UNITED STATES PATENT AND TRADEMARK OFFICE

APPLICATION NO.	FILING DATE	FIRST NAMED INVENTOR	ATTORNEY DOCKET NO.	CONFIRMATION NO.
10/785,209	02/24/2004	Ronald P. Hohmann JR.	PHO-236 CIP	8805
48745	7590	07/13/2007		
SILBER & FRIDMAN 1037 ROUTE 46 EAST SUITE 207 CLIFTON, NJ 07013			EXAMINER FIGUEROA, ADRIANA	
			ART UNIT 3637	PAPER NUMBER
			MAIL DATE 07/13/2007	DELIVERY MODE PAPER

Office Action Summary

DETAILED ACTION

Hohmann (US 4,598,518)

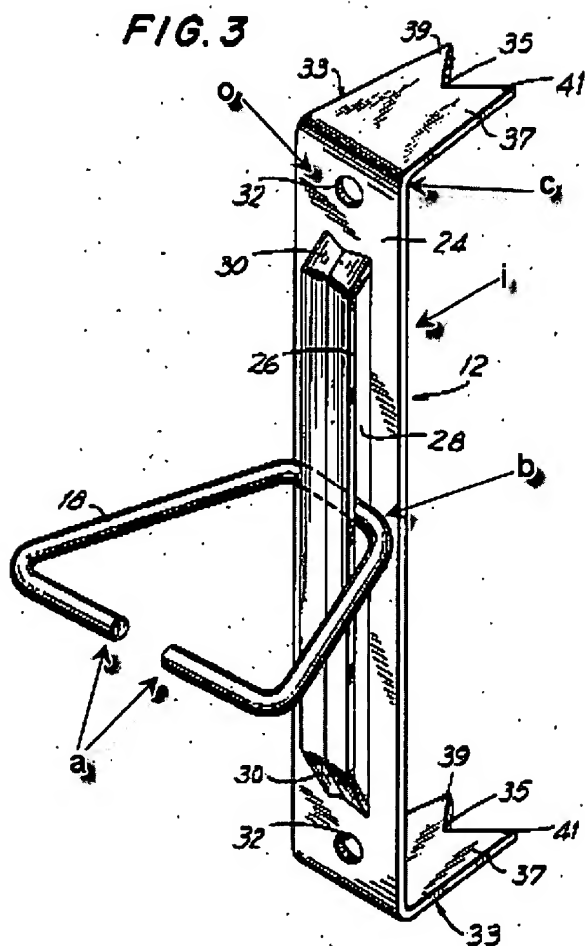
Regarding claims 1 and 13, Hohmann discloses an anchoring system having a wall anchor (12) constructed from a plate-like body (24) having two major faces being the mounting surface (i) and the outer surface (o), said wall anchor, in turn, comprising; a pair of legs (33), each extending from said mounting surface of said plate-like body from an inboard location thereof with the longitudinal axis of each of said legs being substantially normal to said mounting surface (i), (annotated Figure 3).

an apertured receptor portion (28) adjacent said outer surface (o) of said plate-like body (24), (annotated Figure 3). The phrase "adapted to limit displacement of said outer wythe toward and away from said inner wythe" is considered intended use and is given no patentable weight.

and, a veneer tie (18) threadedly disposed through said apertured receptor portion (28) , (annotated Figure 3). The phrase "and adapted for embedment in said bed joint of said outer wythe to prevent disengagement from said anchoring system" is considered intended use and is given no patentable weight.

Regarding claims 5 and 17, Hohmann modified by Frobosilo and Wilhelmi discloses as discussed above, Hohmann also discloses each of said pair of legs (33) extending from said mounting surface (i) of said plate-like body (24), terminate in at least two points (39, 41), (annotated Figure 3). The limitation said inner wythe is a dry-wall is not part of the claim. Therefore it is considered intended use and is given no patentable weight.

an attachment portion (a) for threading through said apertured receptors (28); an insertion portion (b) contiguous with and opposite said attachment portion, said insertion portion being swaged for interconnection with said reinforcement wire, (annotated Figure 3).
